## ASSESSMENT REPORT Flyers Creek Wind Farm MODIFICATION (MP08\_0252 MOD2)

**Figure 2: Project Layout**

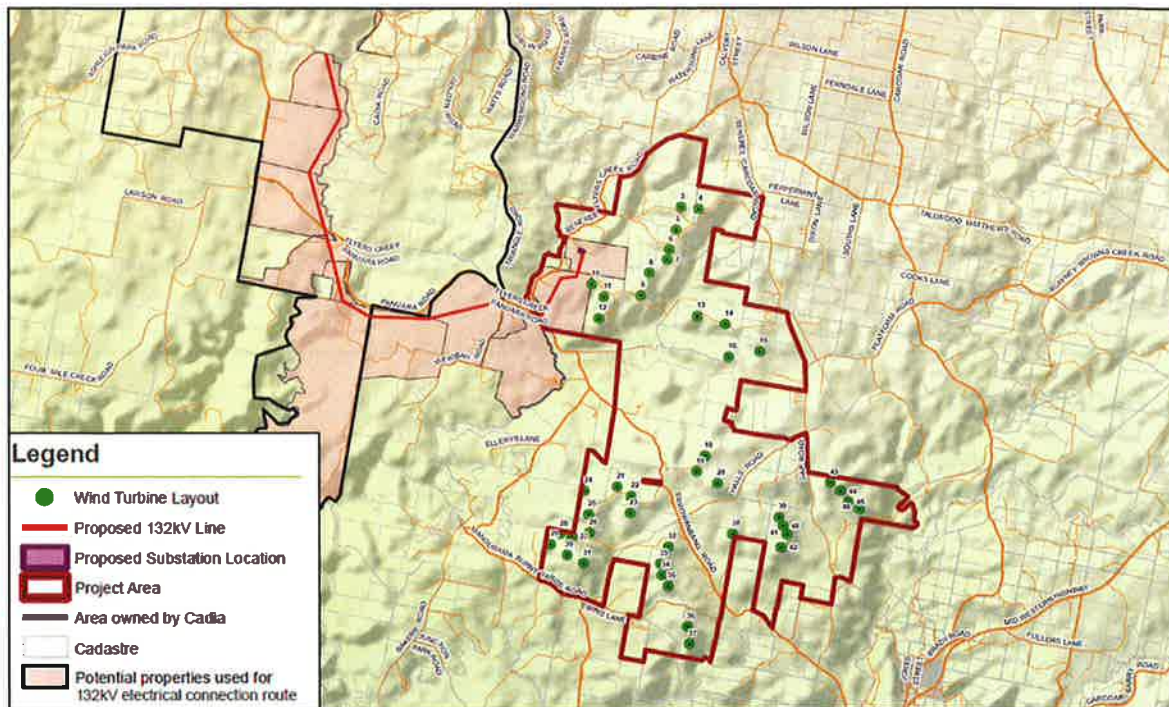
The approved project includes a 132kV transmission line connecting the wind farm with the electricity grid (see Figure 2).

The transmission line is also subject to the deferred commencement conditions. Condition B1a) requires that the Proponent provide evidence to the Secretary that it has 'appropriate access arrangements' in place for land required for the transmission line.

However, the Proponent has advised that it does not have appropriate access arrangements for the subject land, and has requested that the approved transmission line route be removed from the project approval. It has also advised that it is developing an alternative route for the transmission line, and would seek separate planning approval for the transmission line once its plans are further developed.

Given that the removal of the transmission line from the project approval will not, in itself, have any environmental impacts, and there are mechanisms in place to ensure that these changes are adequately assessed, the Department has no objection to the requested change.
